November 1, 2019

RE: KMART REDEVELOPMENT – DRB SUBMITTAL FOR SITE PLAN

DRB PROJECT NUMBER: PR –2019–002677
APPLICATION NUMBER: SI-2019-00252

SHEET: **A202**

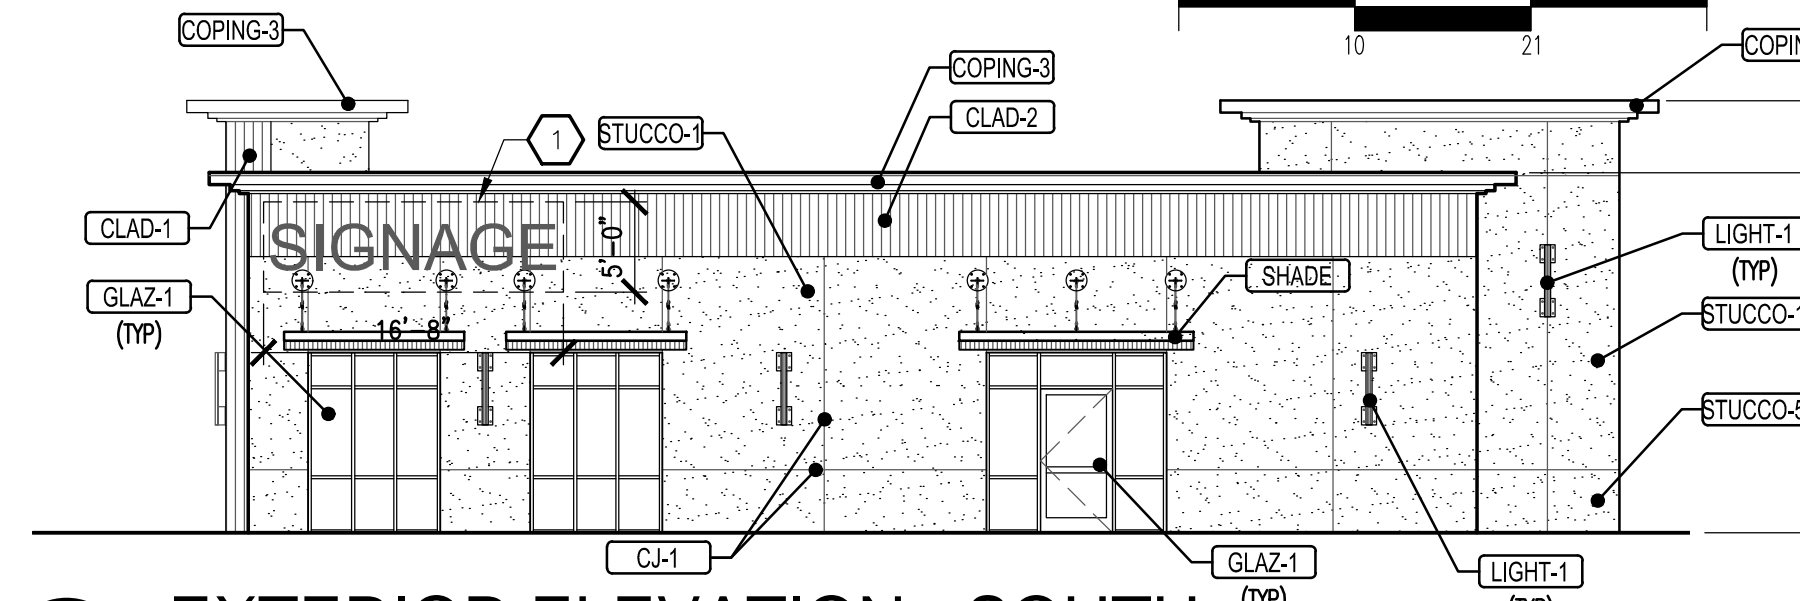
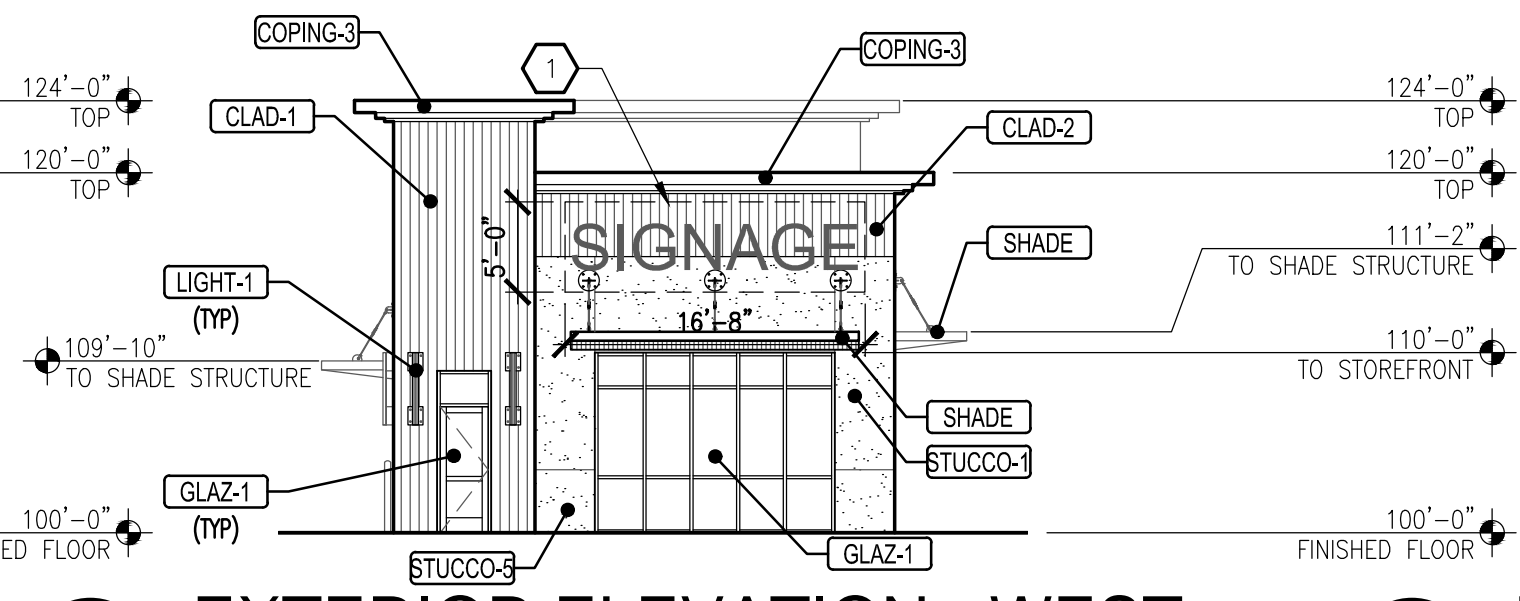
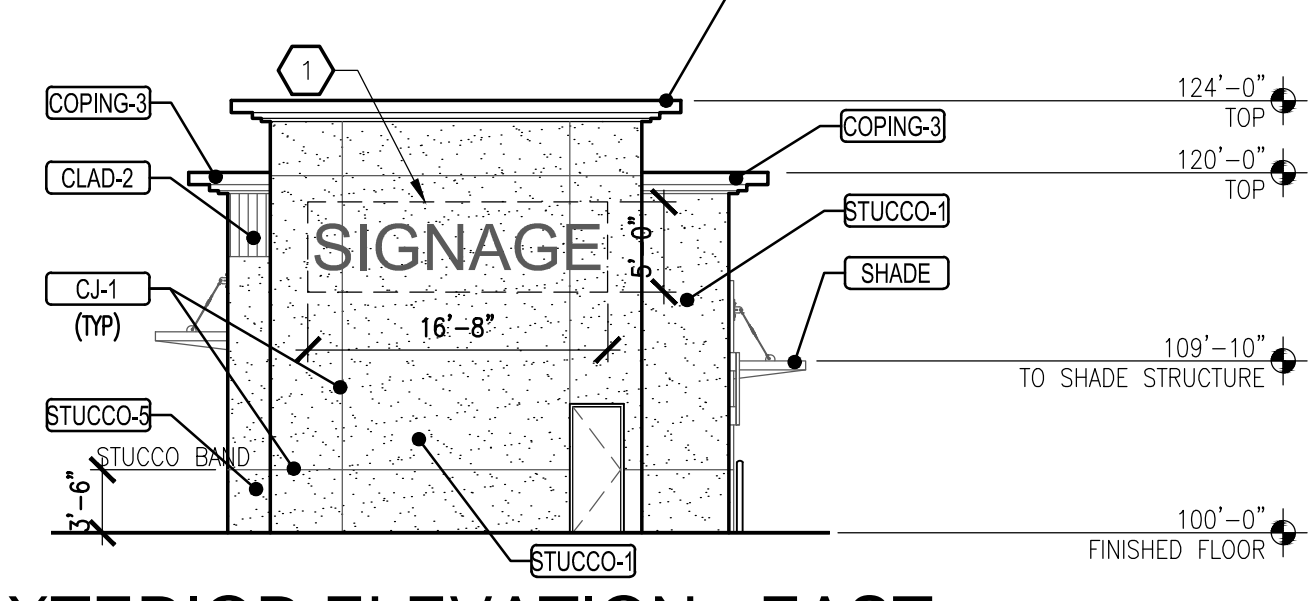
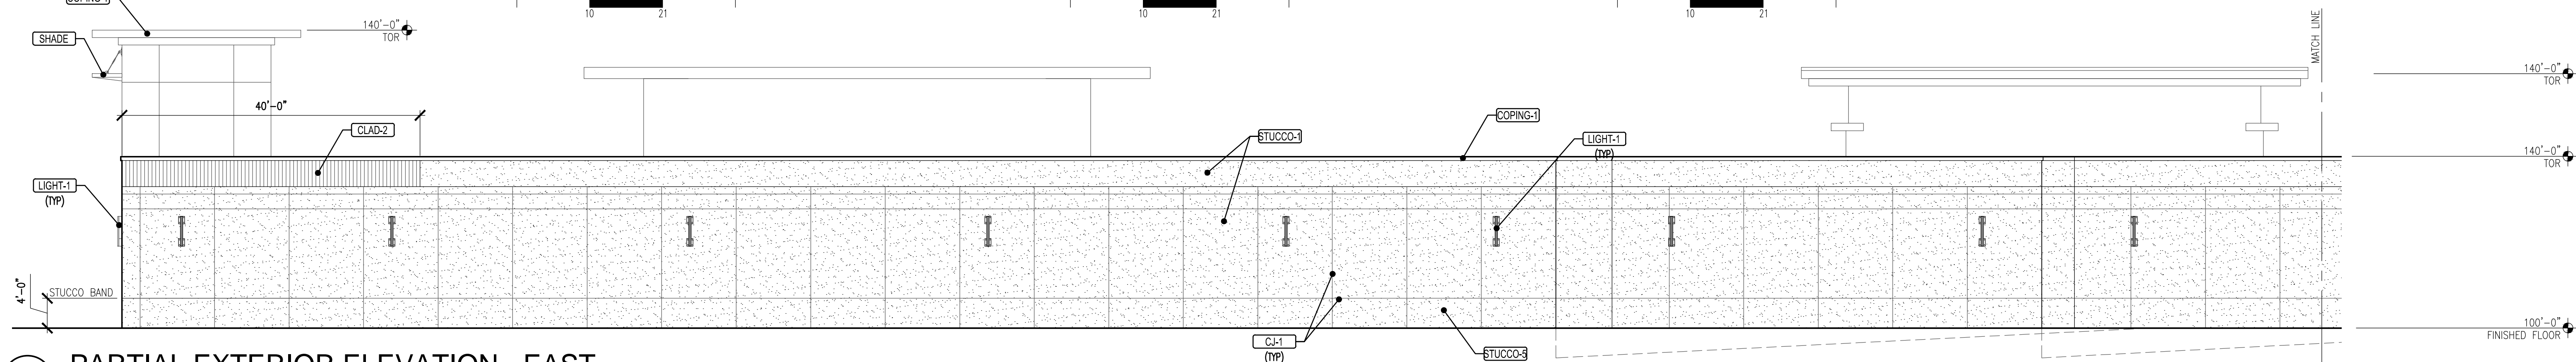
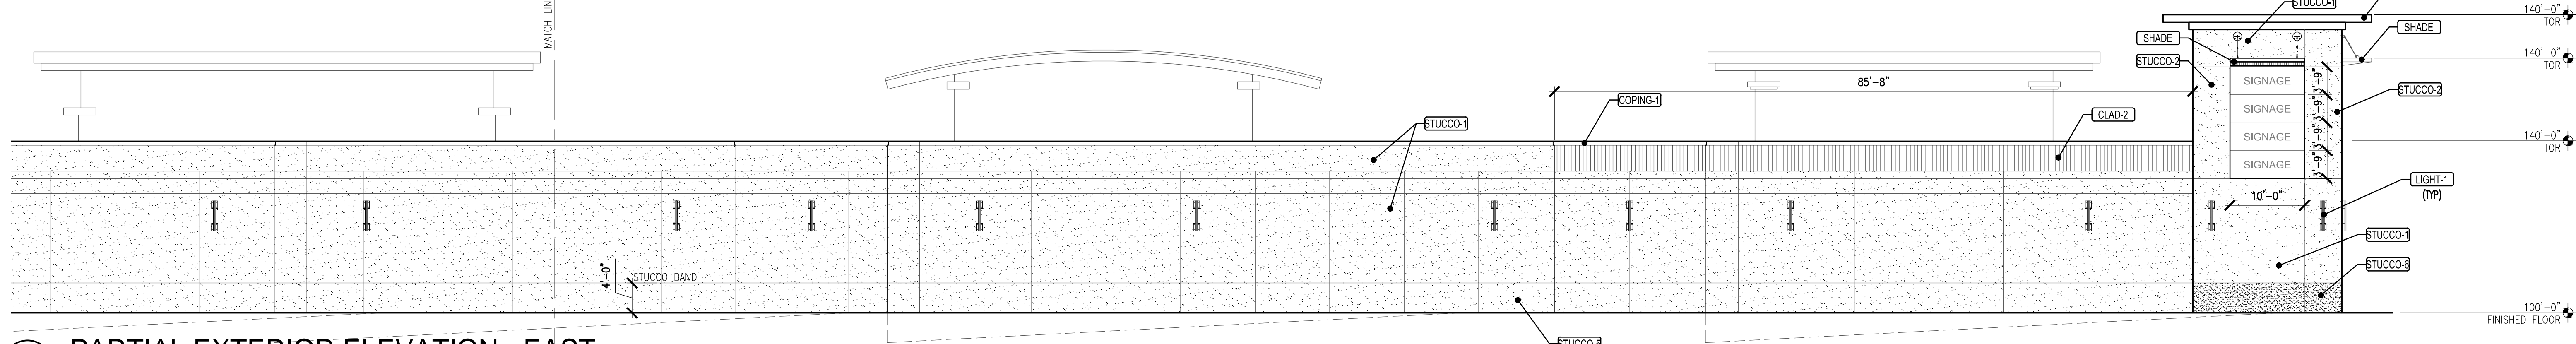
- a. Addressed:
 - i. See revised Exterior Elevation Plans – A201, A202, and A203.
7. A minimum 4-foot wide pedestrian path is needed behind the on-site perpendicular curb ramps for maneuverability. Call out these dimensions. Also call out the 6” high curb on the plan to separate parking areas from on-site pedestrian walkways.
